Modification Changes
- Addition of louvers to podium of the mezzanine level and level 1
- Airlock reconfiguration

Project
WATERLOO METRO QUARTER DEVELOPMENT

Elevation - East

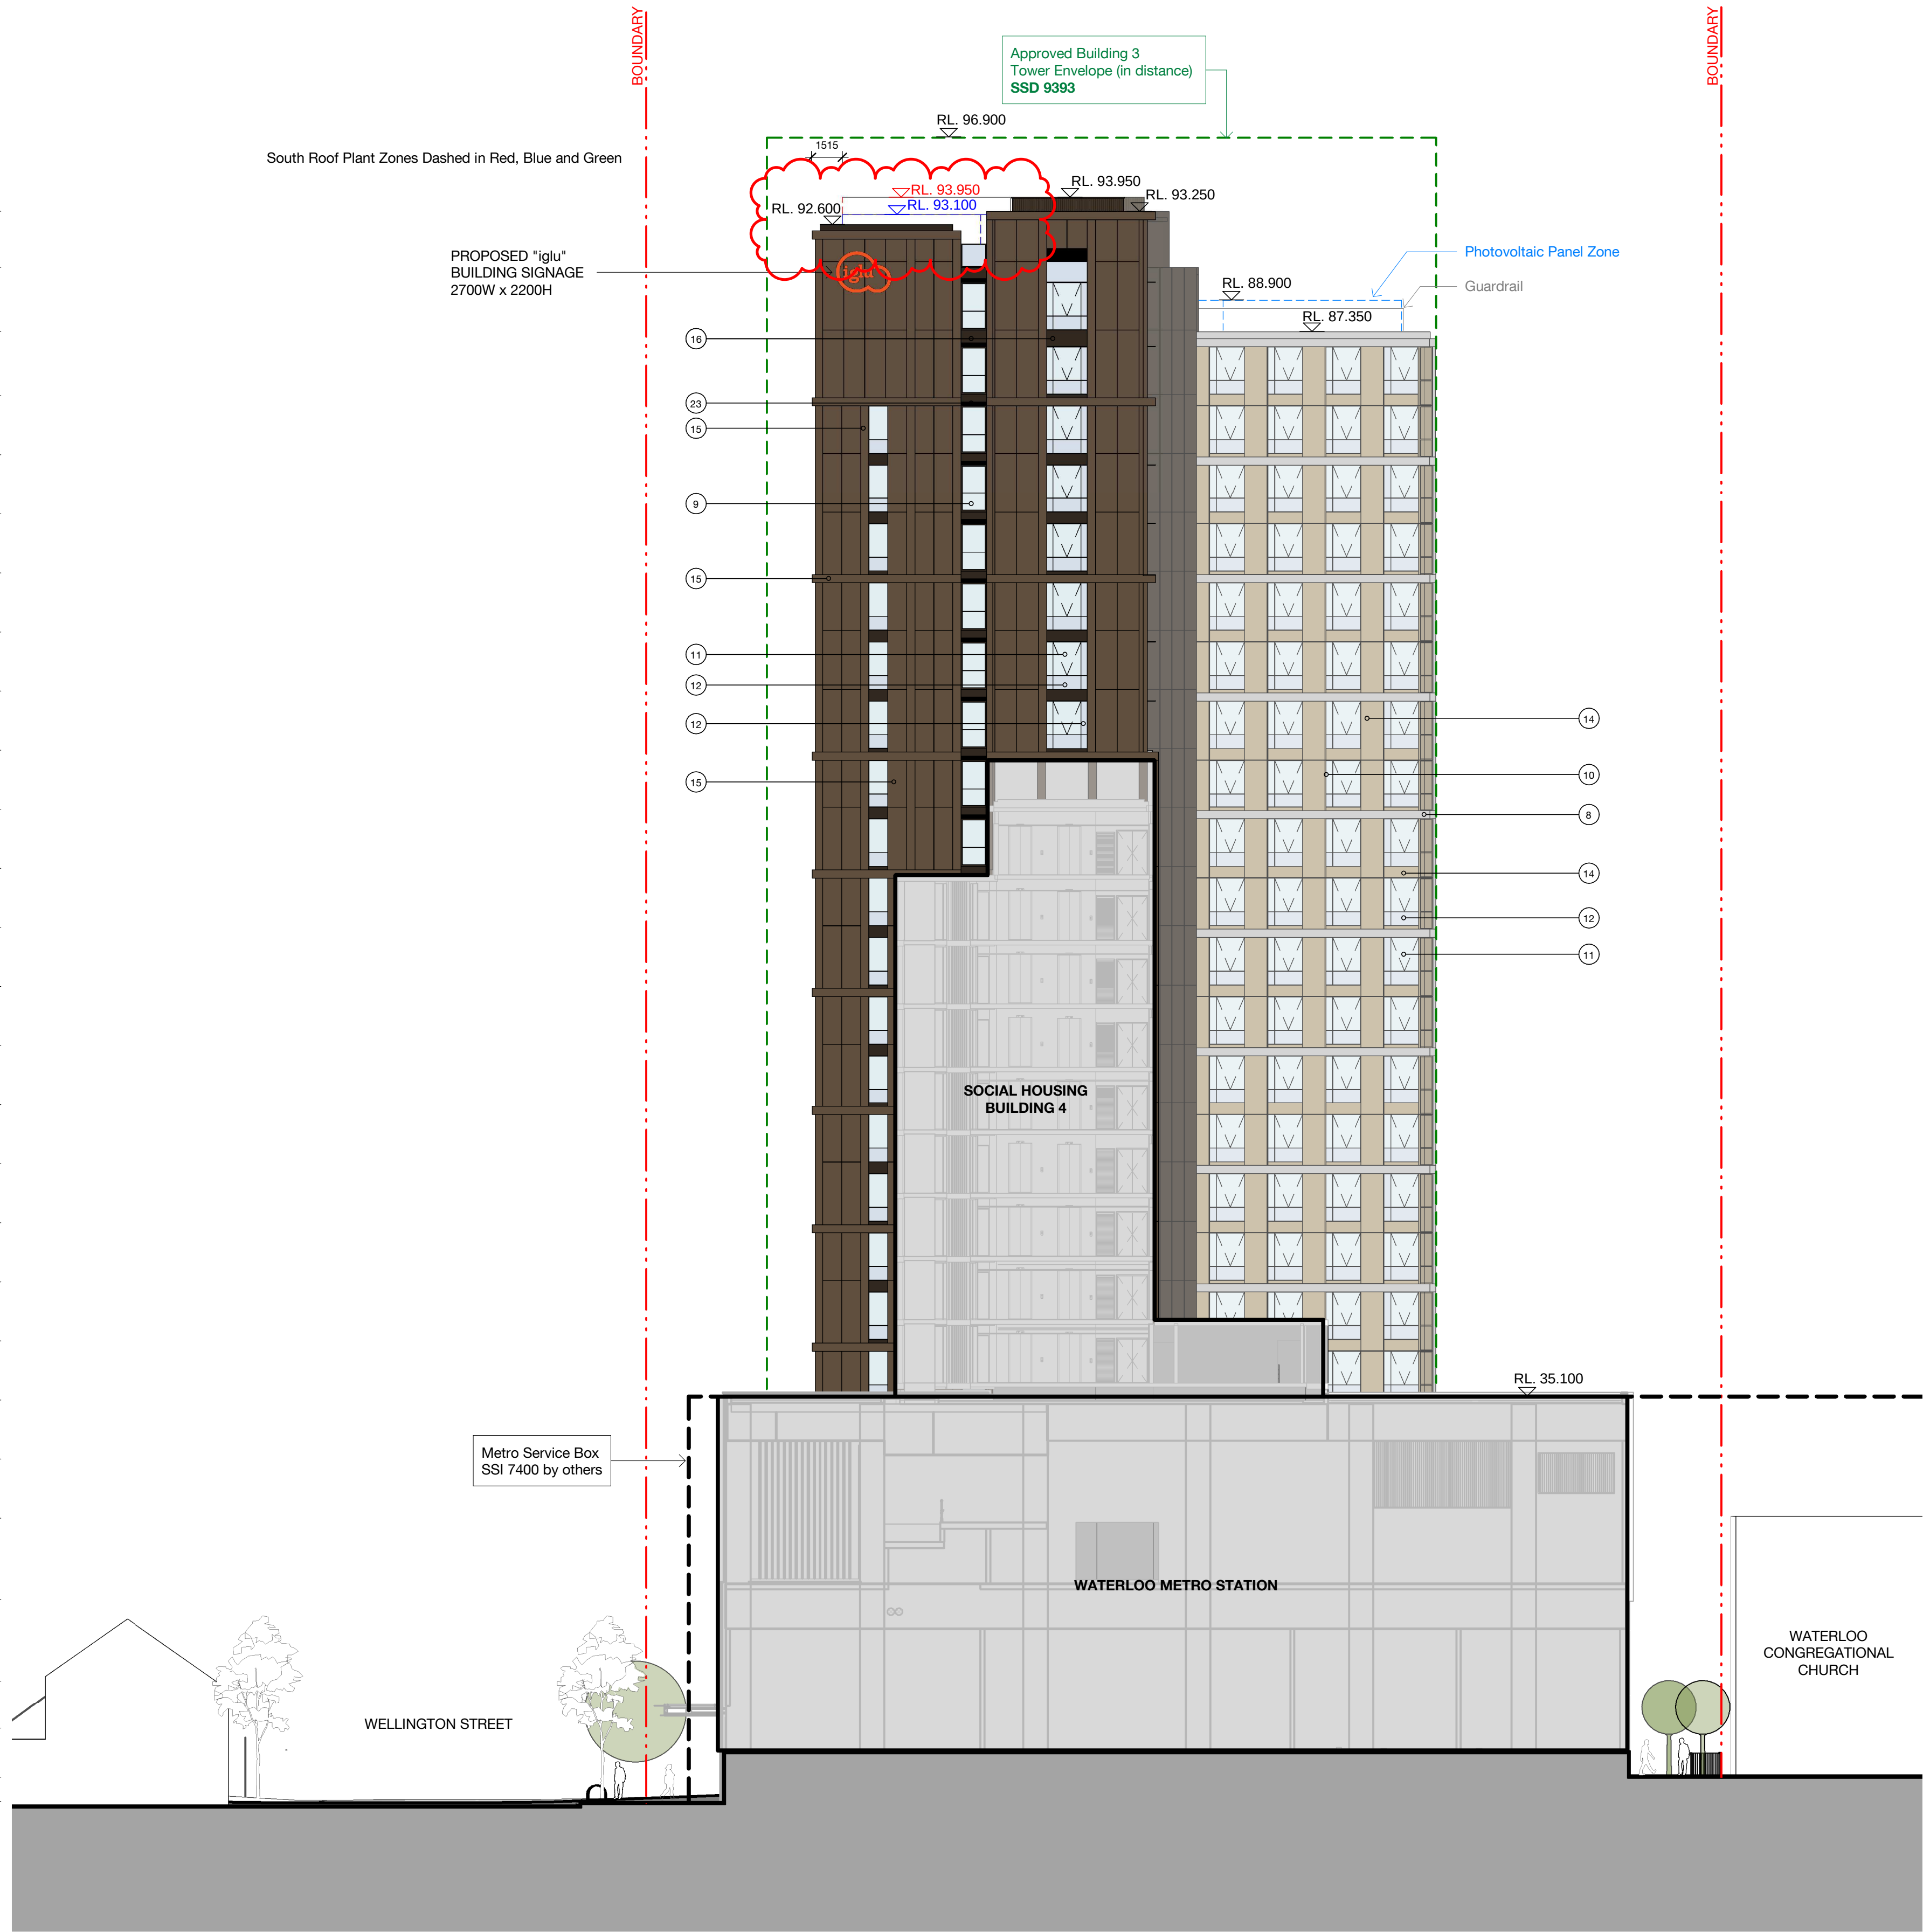
- Roof plant zone

Section E-W

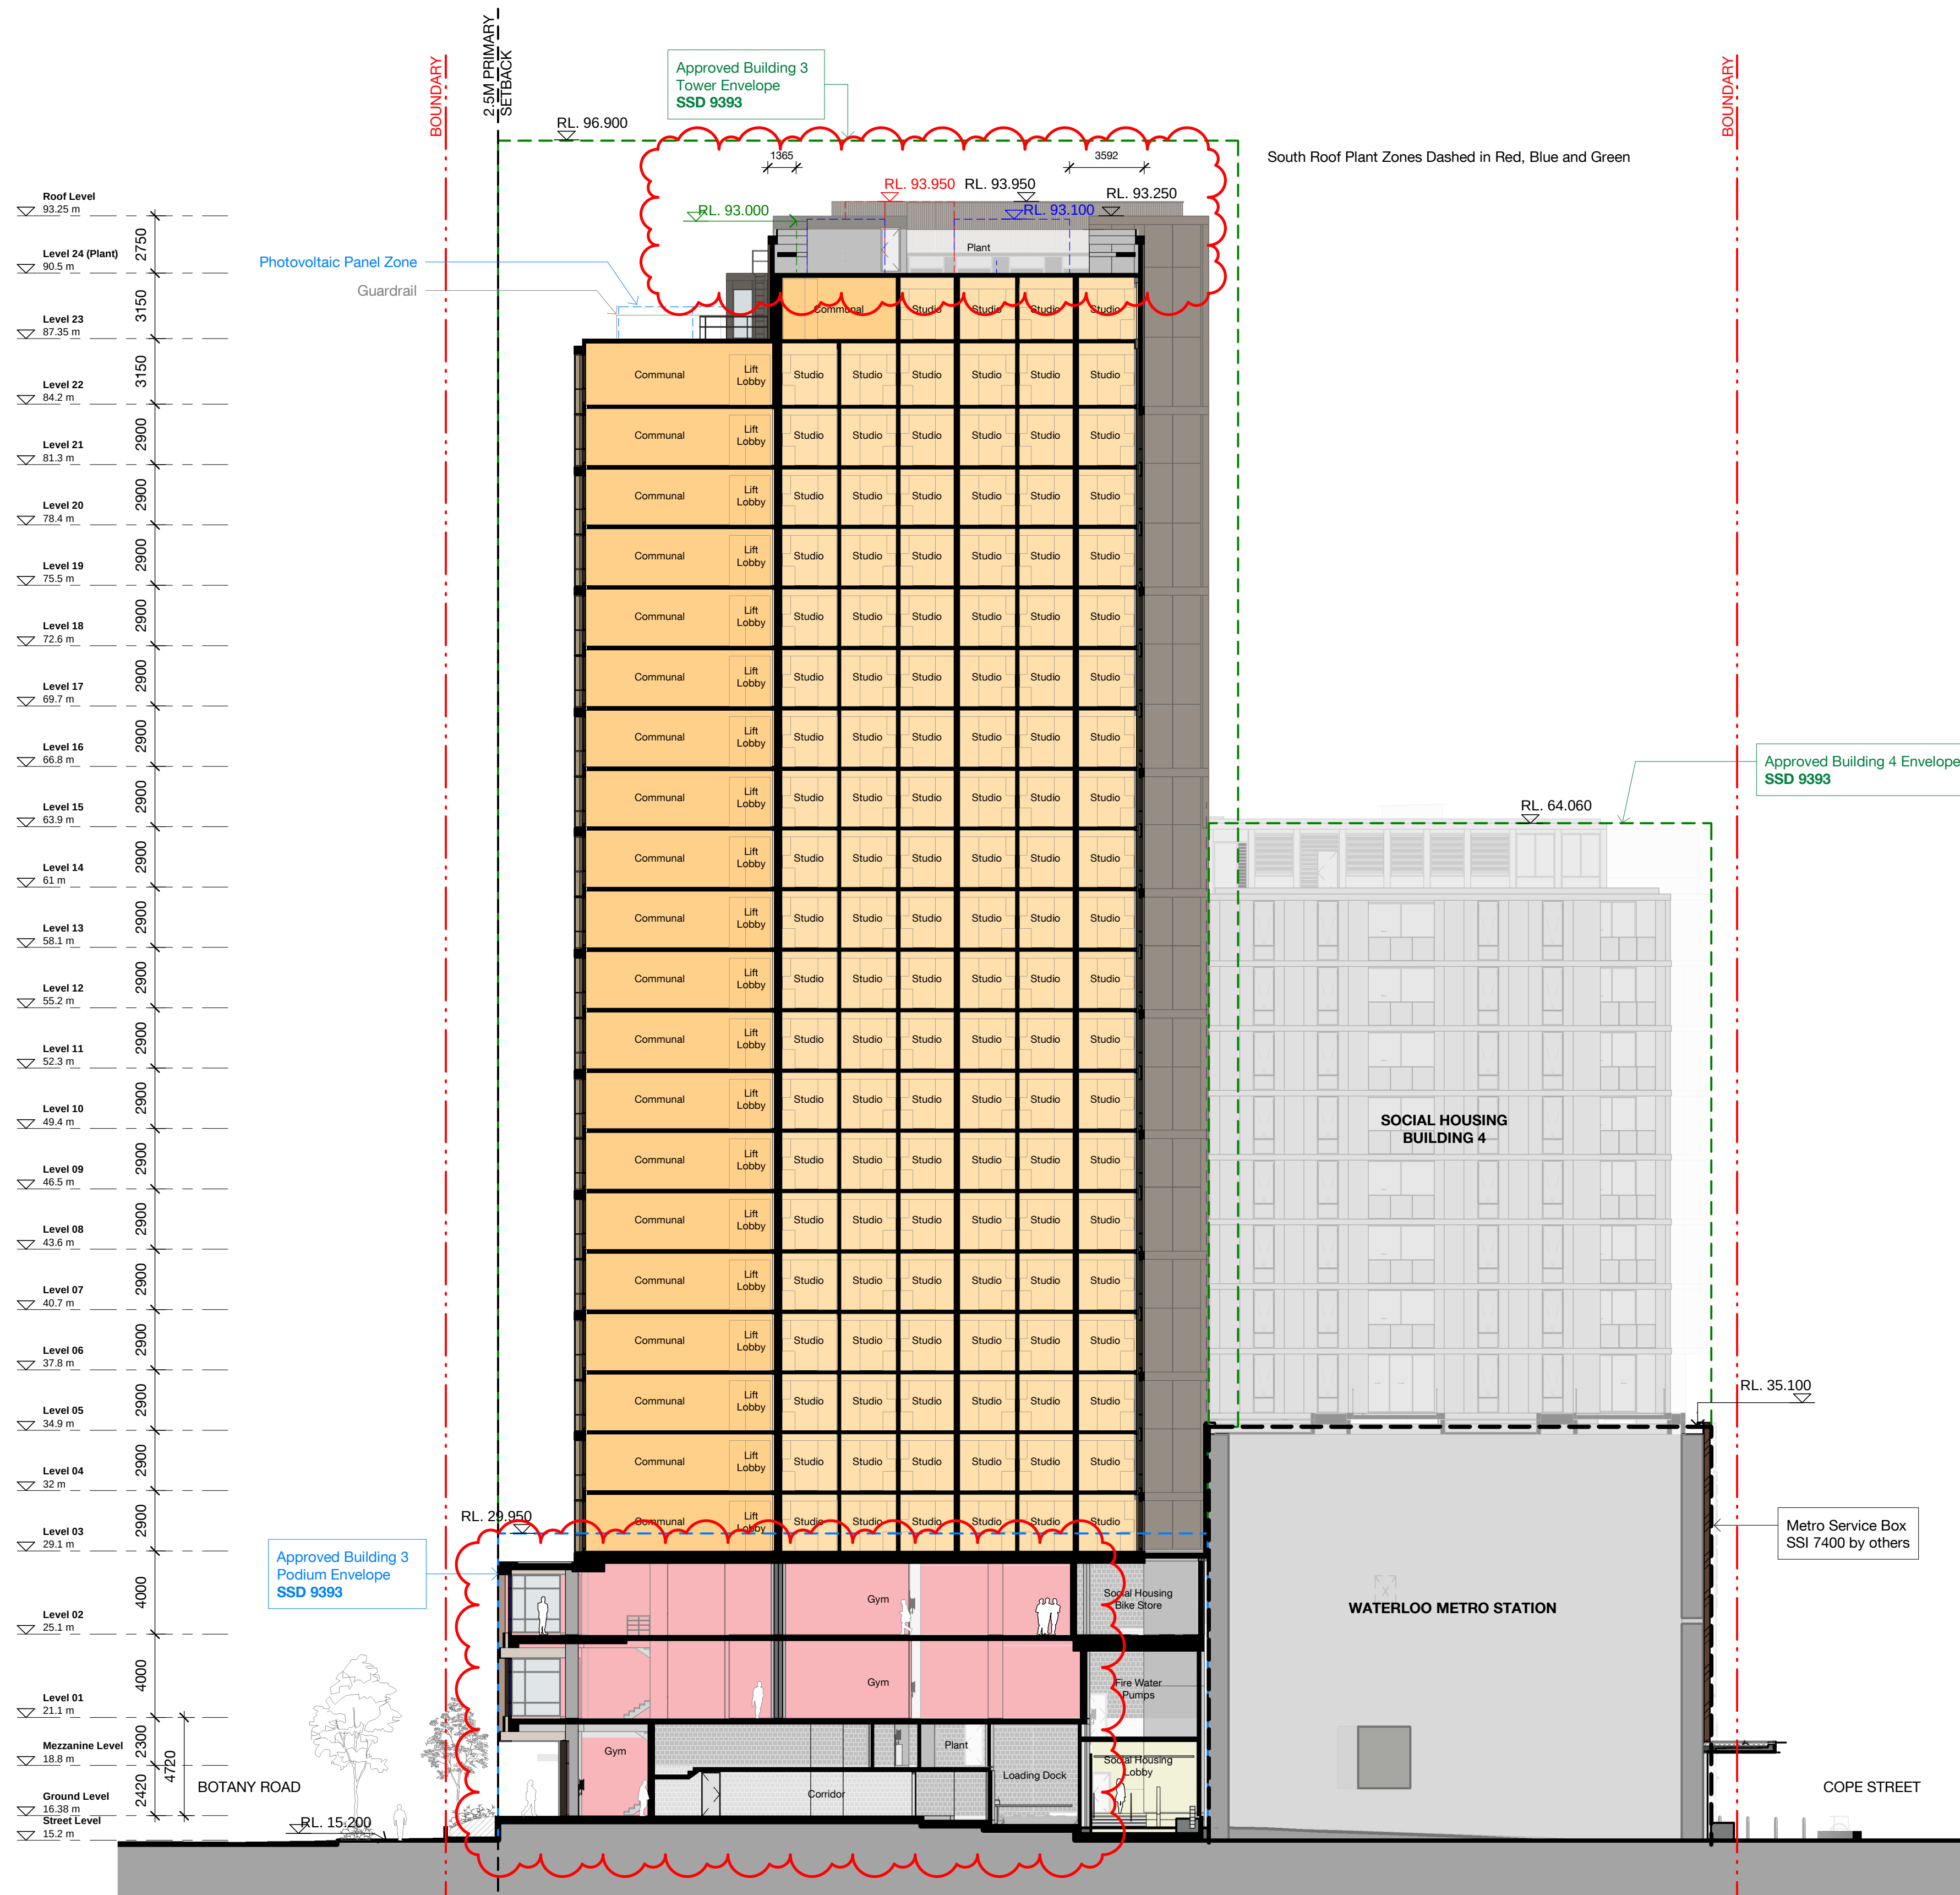
- Modification Changes
- Roof plant zone
 - Gym - lift and stair reconfiguration
 - Addition of block wall and boom gate to loading dock driveway
